**RE: Sceye - Sunport
Conceptual Grading and Drainage Plan
Engineer's Stamp Date: No Date
Hydrology File: M16D024P**

Based upon the information provided in your submittal received 01/18/2024, the Conceptual Grading & Drainage Plans are preliminary approved for action by the Development Facilitation Team (DFT) on Site Plan for Building Permit.

Project Title: Sceye, Inc. - New Manufacturing Facility Hydrology File # _____

REVISION	
PROJECT NUMBER	15440
DATE	1/18/24
DESIGNED	JRH/ELS
DRAWN	ELS
REVIEWED	JRH
SHEET TITLE	Conceptual Grading & Drainage Plan
SHEET NUMBER	1/1

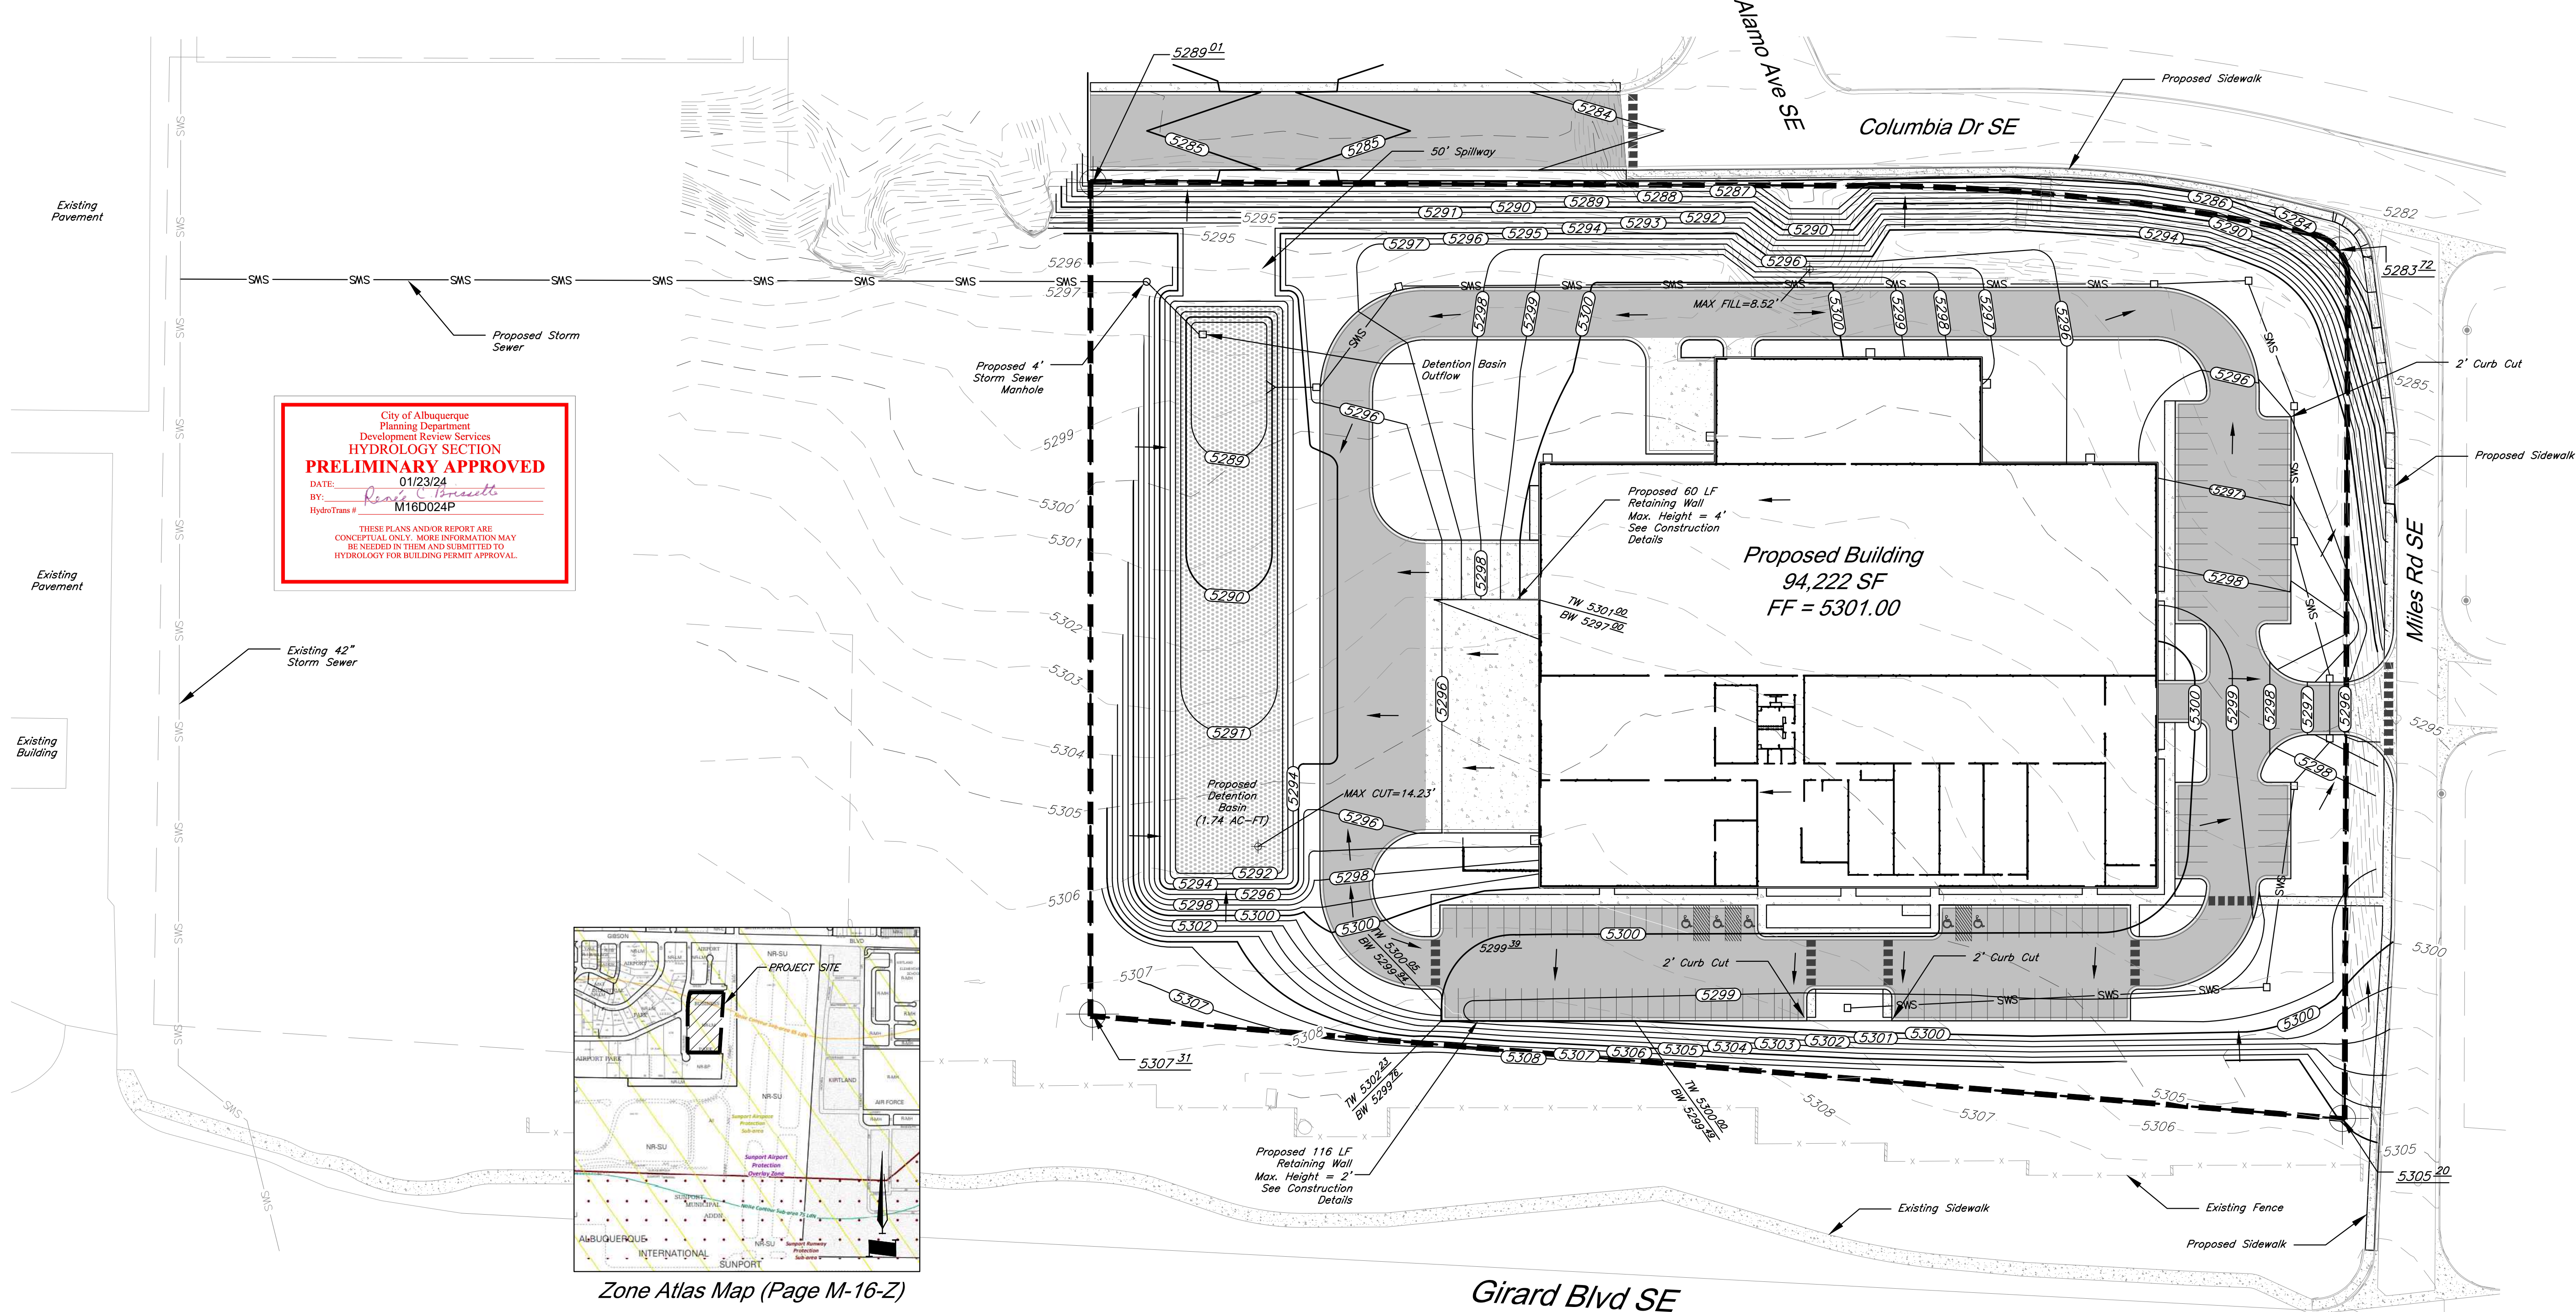
1. Please submit a more detailed Grading & Drainage Plan to Hydrology for review and approval. This digital (.pdf) is emailed to PLNDRS@cabq.gov along with the Drainage Transportation Information Sheet.
2. The outfall pipe for the detention pond should fall within the roadway (I don't know if this is just a private roadway or a public R.O.W. instead of how you are placing it. This should RCP within the roadway with some sort of outflow structure within the detention pond.

3. The emergency spillway can be lessened in size from 50 ft width and the length can be figured out by using the weir calculations, per DPM Article 6-16(A). A coefficient of 2.7 is typically used for the weir equation $Q = CLH^{2/3}$.

4. At the end of the proposed roadway, a temporary retention pond (sized for the 100 year – 10 day volume) for only the small drainage area of the roadway plus the discharge from the emergency spillway of the detention pond.
